CHAPTER 2 MODIFICATIONS, ADDENDA AND CORRECTIONS

MODIFICATIONS AND ADDENDA

This chapter includes new or revised information that replaces or amends the information in the Draft Environmental Impact Statement (EIS). This chapter is organized by Draft EIS sections.

**Figure 2.2-1
Location of Alternative
Pipeline Routes**

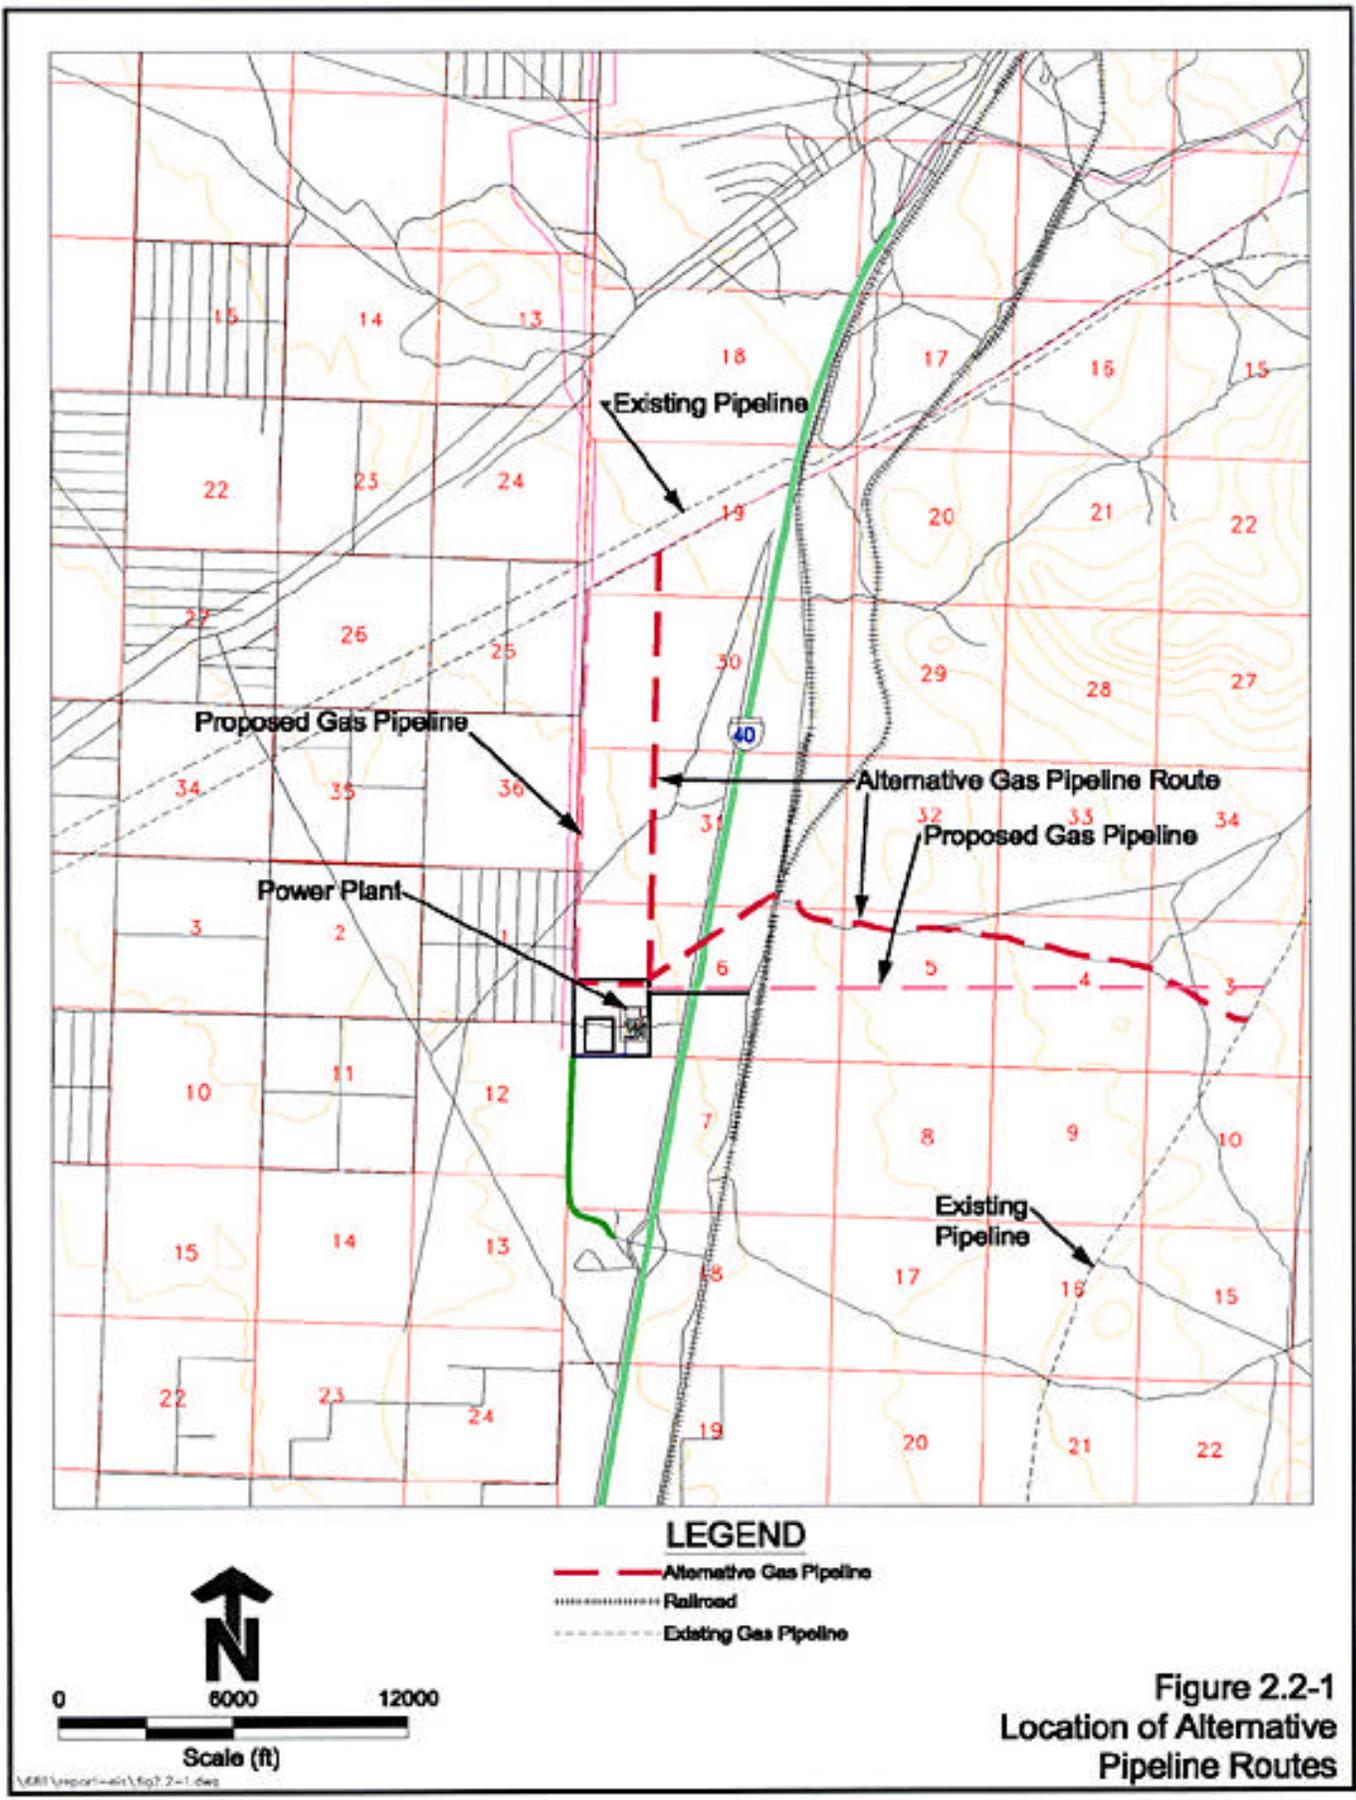
Replace Section 2.2.1.1 Alternative Gas Pipeline Routes with the following:

An alternative route for the proposed natural gas supply pipeline between the Plant site and the EPNGC transmission line has been proposed by the BLM. This alternative would follow the existing roads on BLM lands (**Figure 2.2-1**). The proposed alternative route would traverse northeasterly across private and BLM lands until it intercepts the existing BLM roads that it would follow to the interconnection with the EPNGC line. Most of the ROW for the alternative route would be returned to use as an improved road. Portions of the construction ROW not needed for the road would be reclaimed as specified by the BLM.

An alternative route for the proposed natural gas supply pipeline between the Plant site and the Transwestern transmission line is being considered. This alternative would travel due north from the Plant site either in the County road ROW located ½ mile east of the western boundaries of sections 6, 31,30, and 19, T20N, R17W or near this ROW in a separate easement. This route is shown on **Figure 2.2-1**. After construction, the ROW would be reclaimed to landowner specifications.

Figure 2.2-1a
Location of Alternative
Equipment Haul Route

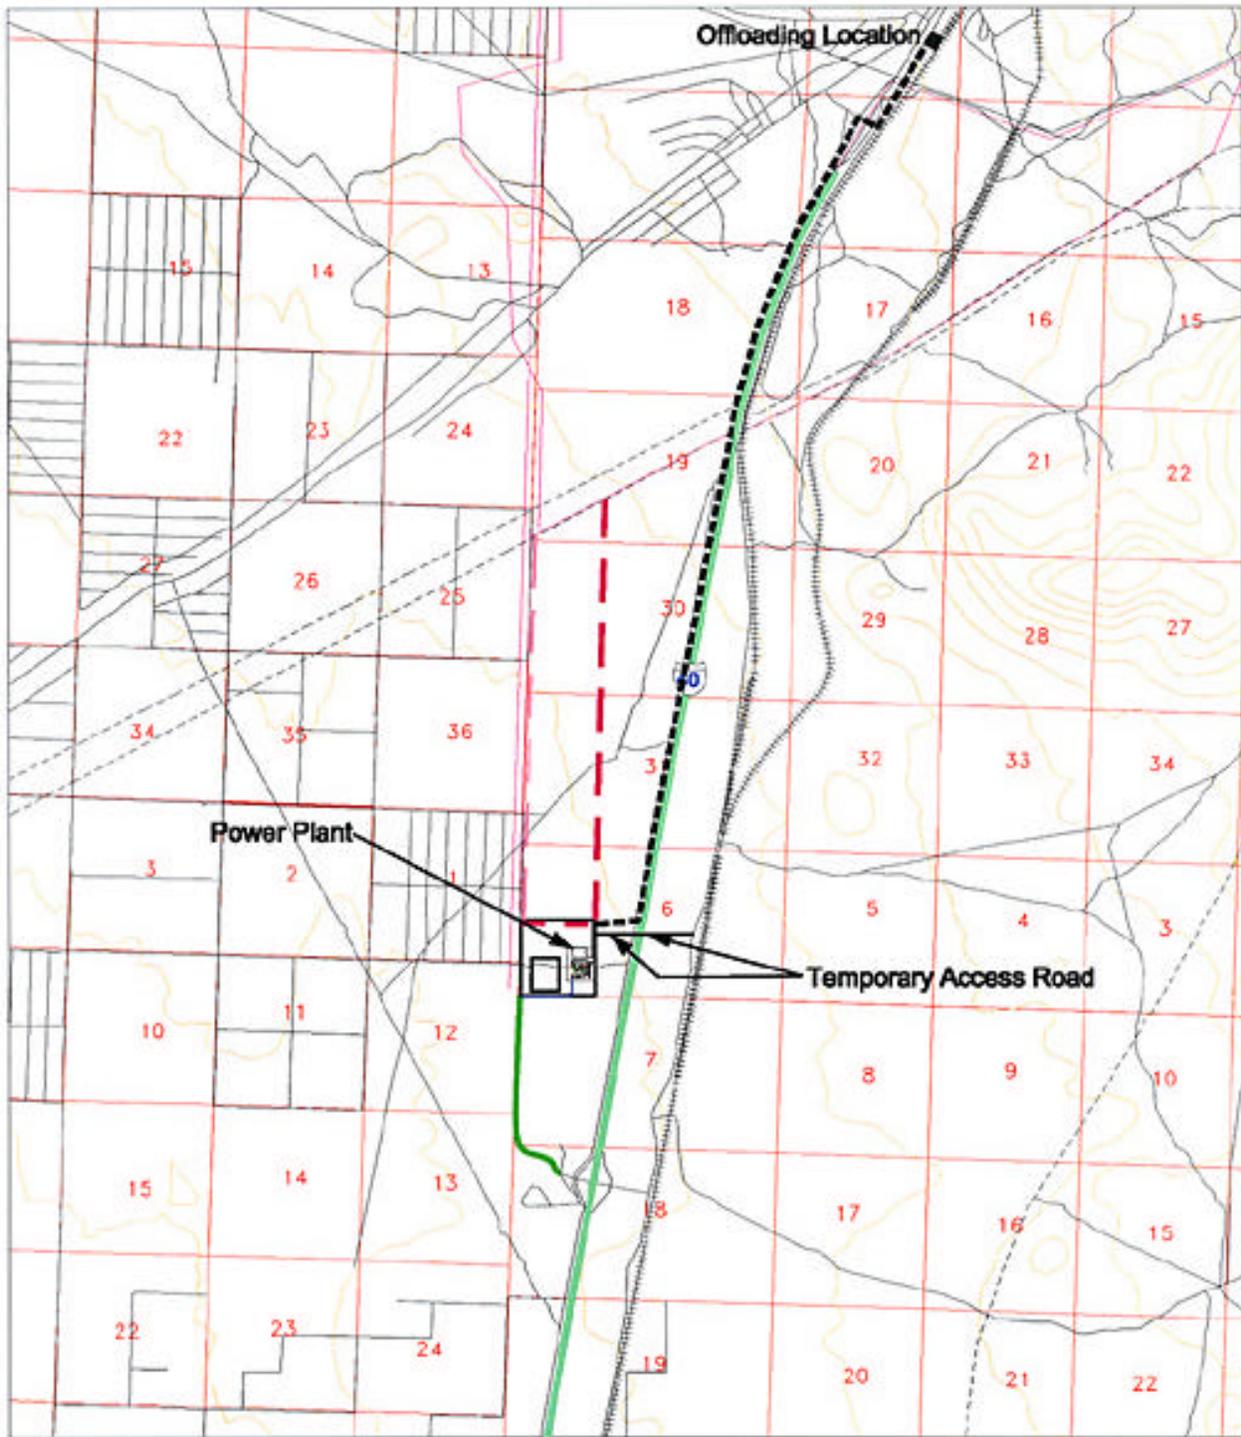
Insert the following under Section 2.2.1 Power Plant and Associated Facilities:

An alternative temporary haul route for the delivery of major, heavy equipment to the Plant site has been developed to better use existing local rail facilities. Under this alternative, instead of building a new temporary area to offload equipment at the rail siding due east of the Plant site, equipment would be offloaded at an existing facility at a truckstop approximately six miles north of the Site (see **Figure 2.2-1a**). From there, the equipment would be trucked south on I-40 where it would access the Plant site via the same temporary haul road originally proposed.

Figure 2.2-1b shows the details of how the trucks would access I-40 from the truckstop. Most haul trips would occur at night to minimize traffic impacts. Traffic control, fencing, and reclamation would be conducted in compliance with an Encroachment Permit to be obtained from the Arizona Department of Transportation.

The use of an existing railroad off-load facility on private land and paved access to the paved I-40 frontage road would limit new disturbance associated with the temporary haul road to approximately 0.25 miles between the Plant site and I-40. As this alternative route would not cross public lands administered by the BLM east of I-40, a grant of right-of-way from the BLM would not be required.

Figure 4.9-9
Recreation & KOPs

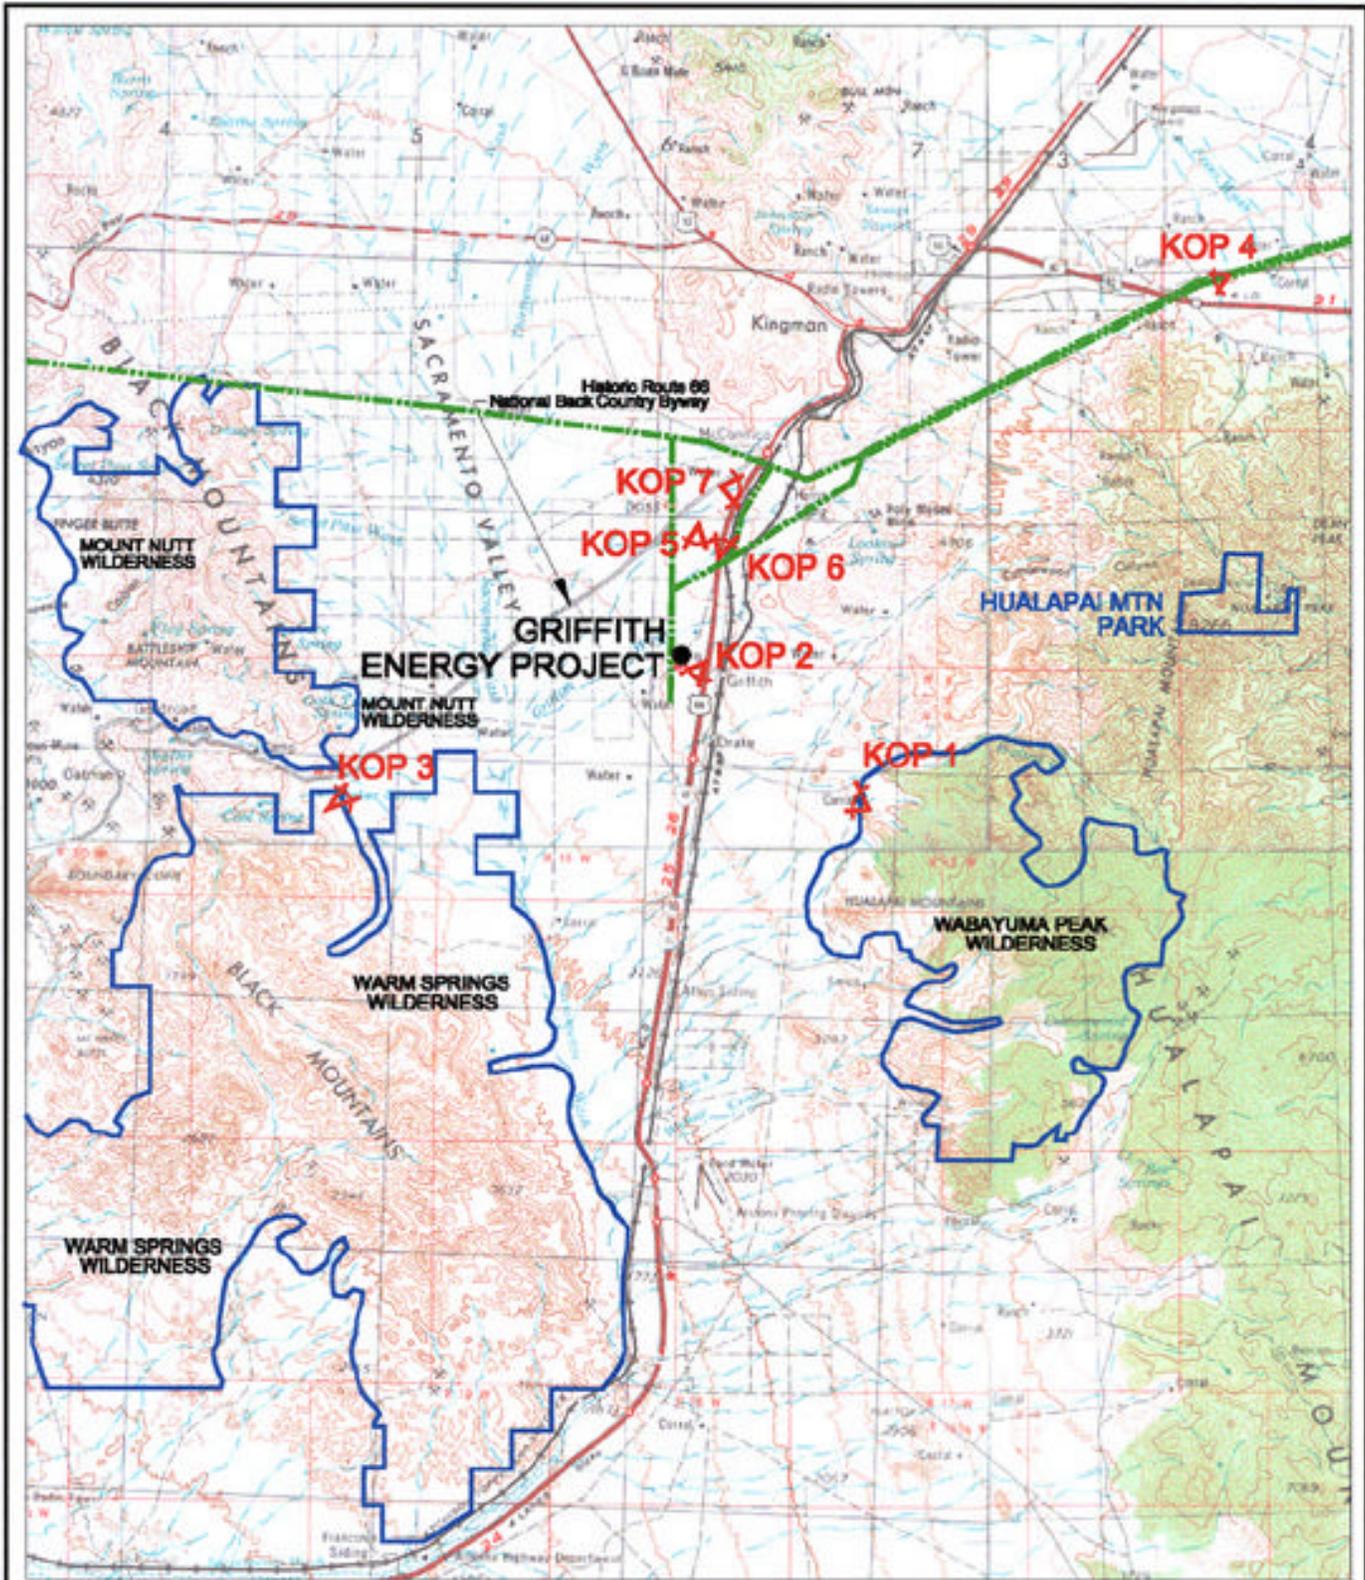
Figure 4.9-4 through **4.9-8** each depict a simulation of transmission line facilities that would be visible from the KOPs 4, 5, 6 and 7, the locations of which are shown on **Figure 4.9-9**. None of the transmission line facilities would be visible from the three nearby wilderness areas. The proposed facilities are located at distances from the wilderness areas that preclude visibility.
